Product Support Bulletin 2009-006

SUBJECT: Workhead Slider Stop Bolt Kit – 98310008

MACHINE MODEL(S): SP2R Dual Rail Spike Puller

Figure 1

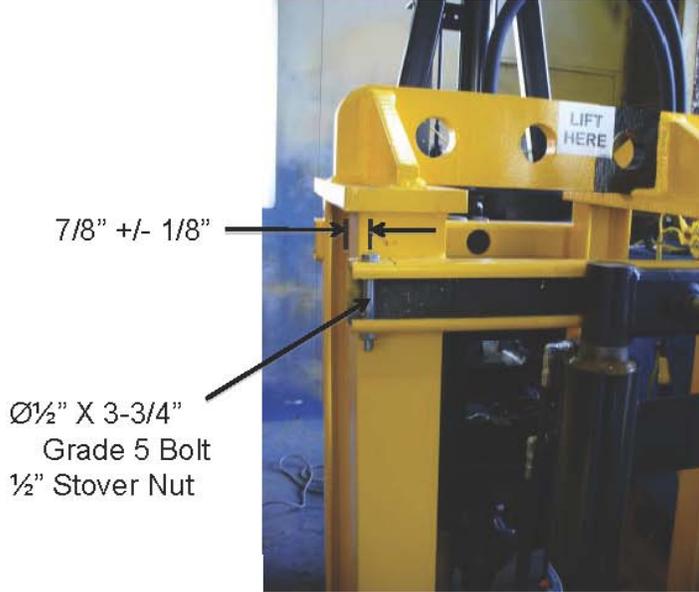
SUMMARY: There have been reports of the lower front cab windows being broken by the Pulling Head if the Pulling Head Spotting Cylinder or its attachment bracket breaks. Installing this kit will limit the Pulling Head travel and prevent contact with the cab windows.

Purpose: To prevent pulling heads from sliding into cab in the event of a spotting cylinder failure.

1. Drill Ø.531 hole thru channels as shown – top slider channels at cab end.

2. Install supplied 1/2" bolts and stover nuts.
